Service Bulletin

BULLETIN NO: KX 155A-11
KX 155A VHF NAV/COMM Transceiver

Mod 11 replaces the Transmitter Module with one that is more reliable in high VSWR installations.

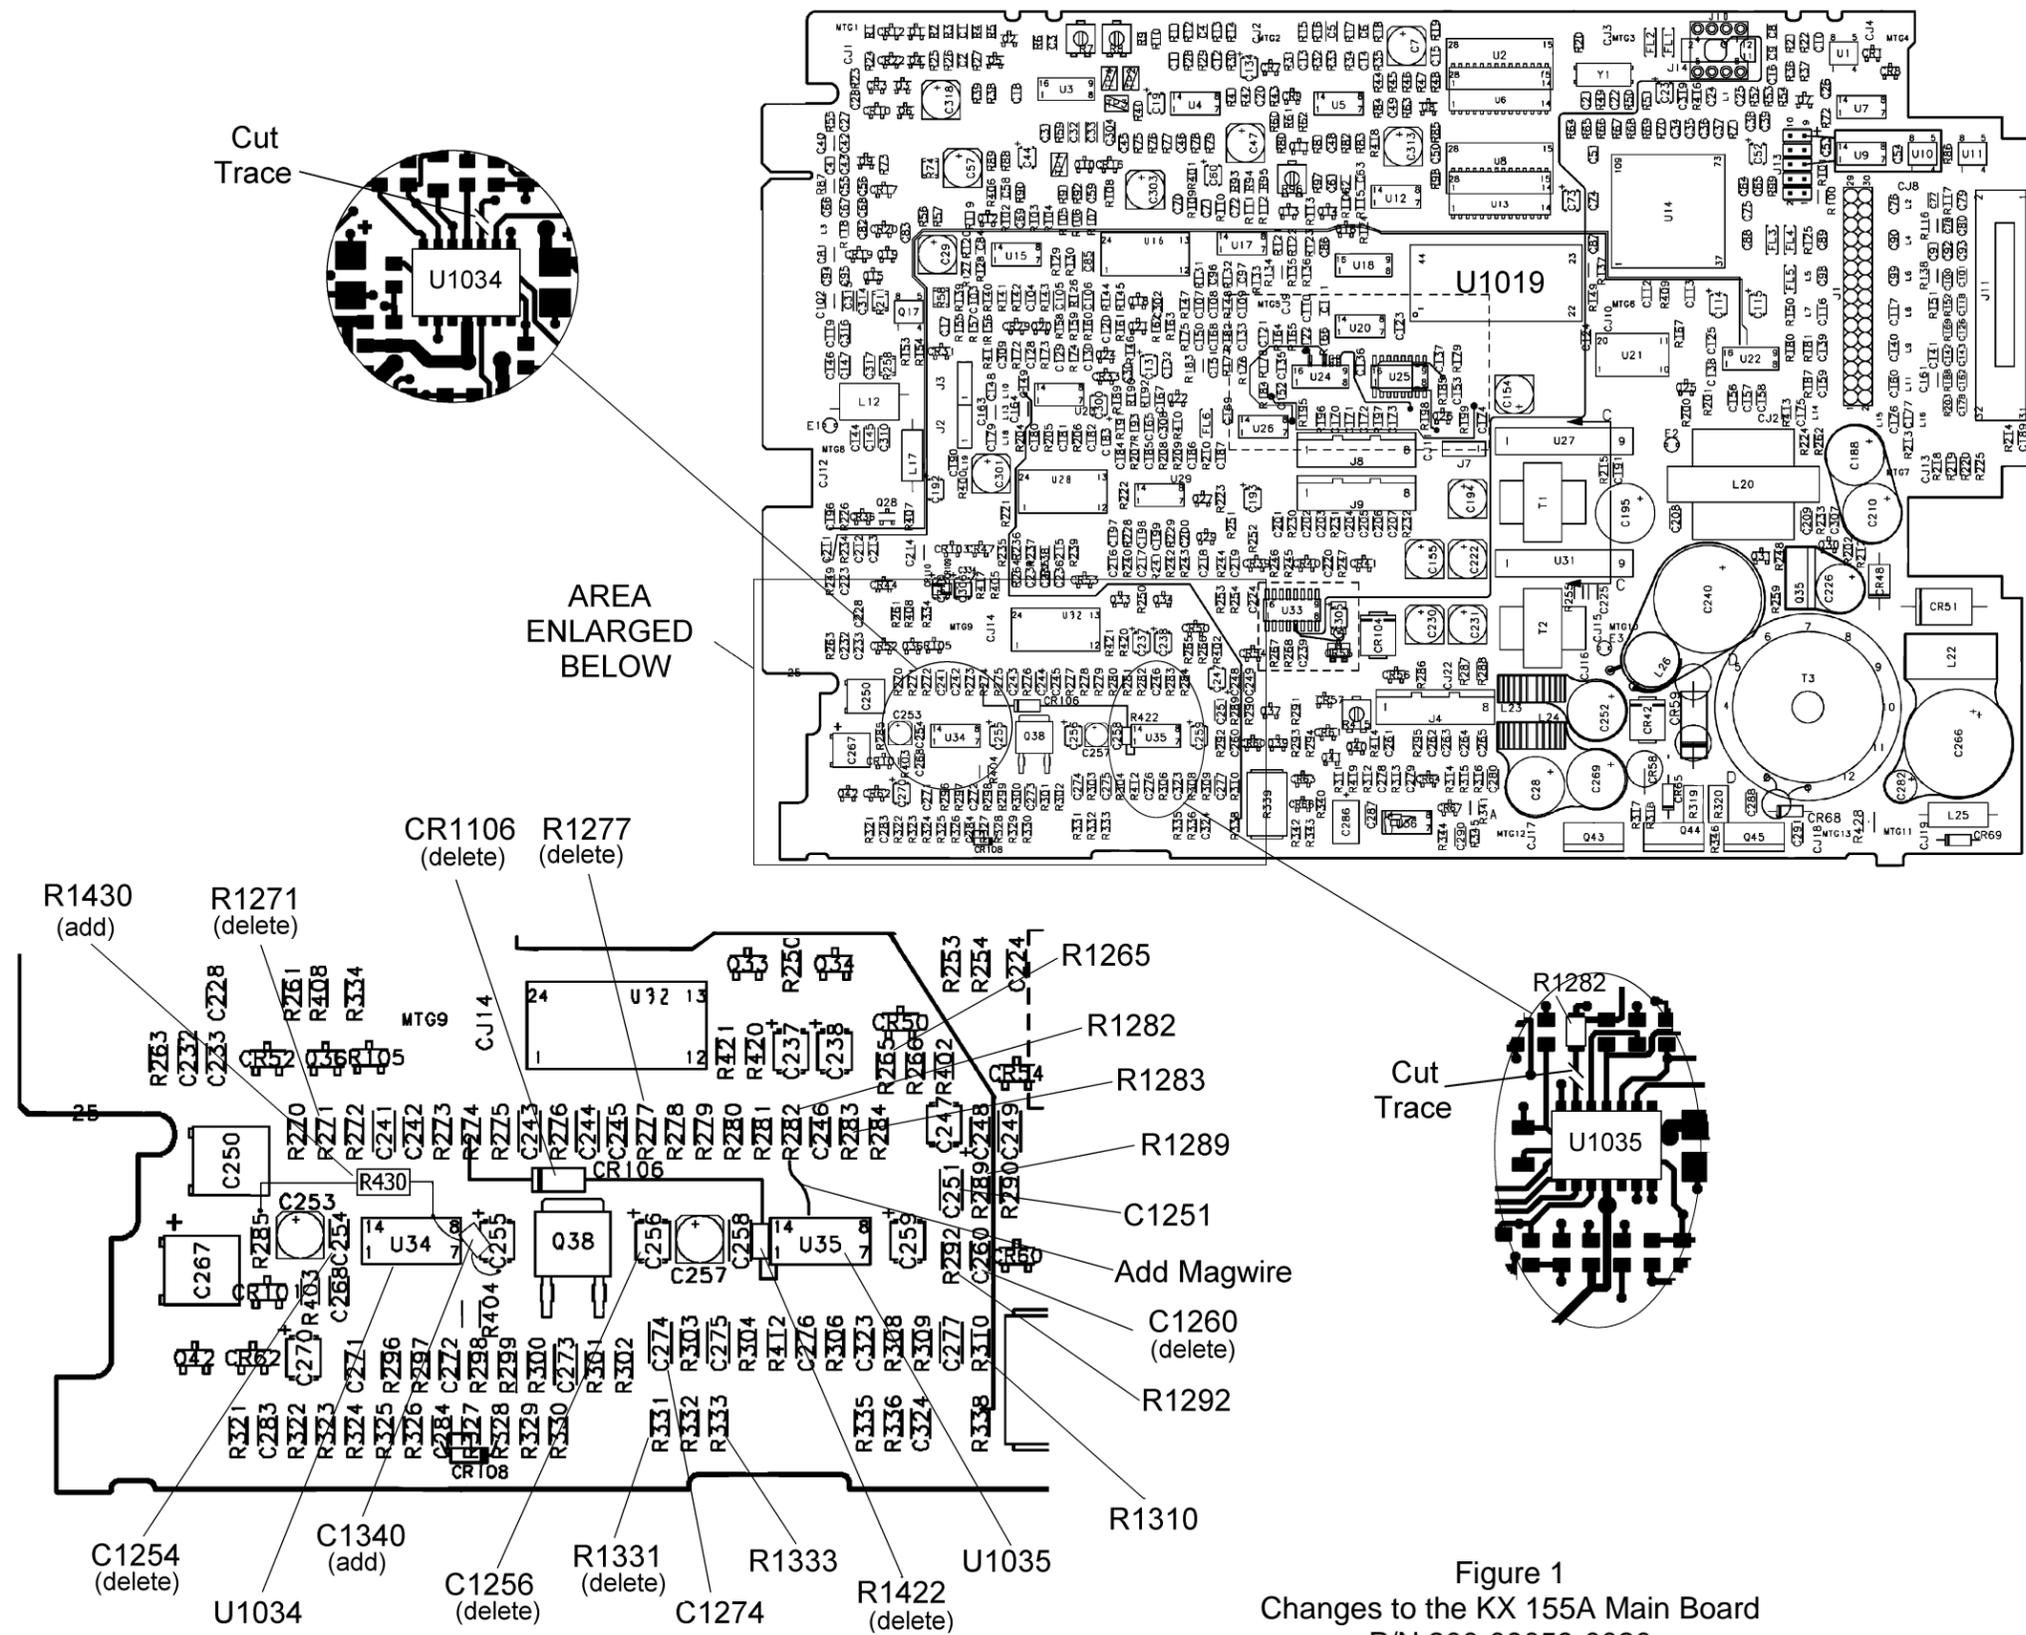
2. Replace Transmitter Module P/N 200-09062-0010 with new Transmitter Module P/N 200-09062-0020.
3. Complete the following changes to the Main Board. These changes convert the Main Board from P/N 200-09059-0020 to P/N 200-09059-0050. Refer to Figure 1.
 - A. Remove and discard C1254, C1256, C1260, CR1106, R1271, R1277, R1331, and R1422.
 - B. Replace C1251 with new C1251 P/N 106-04474-0037.
 - C. Replace C1274 with new C1274 P/N 106-04332-0016.
 - D. Replace R1265 with new R1265 P/N 139-00000-0014.

- E. Replace R1283 with new R1283 P/N 139-02001-0010.
- F. Replace R1289 with new R1289 P/N 139-02002-0010.
- G. Replace R1292 with new R1292 P/N 139-00000-0014.

- H. Replace R1310 with new R1310 P/N 139-04222-0010.
- I. Replace R1333 with new R1333 P/N 139-01002-0010.
- J. Replace U1034 with new U1034 P/N 120-03552-0000.

- K. Replace U1035 with new U1035 P/N 120-03552-0000.
- L. Install new R1282 P/N 139-02001-0010.
- M. On the nearside of the board, cut the trace between U1035 pin 13 and R1282. Solder a magwire from U1035 pin 12 to the R1282 pad that is closest to U1035.

- N. Cut the trace that goes from U1034 pin 10. Install R1430 P/N 131-00203-0013 between U1034 pin 10 and the lead of R1285 that is closest to C1250. Apply insulating tubing P/N 150-00004-0010 as appropriate over the lead.

- O. Install C1340 P/N 111-00001-0001 between U1034 pin 10 and ground (the negative side of C1255).
- P. If the software level of the KX 155A is SW Mod 01/05, update it to SW Mod 01/06 using Software Diskette P/N 225-00014-0005.
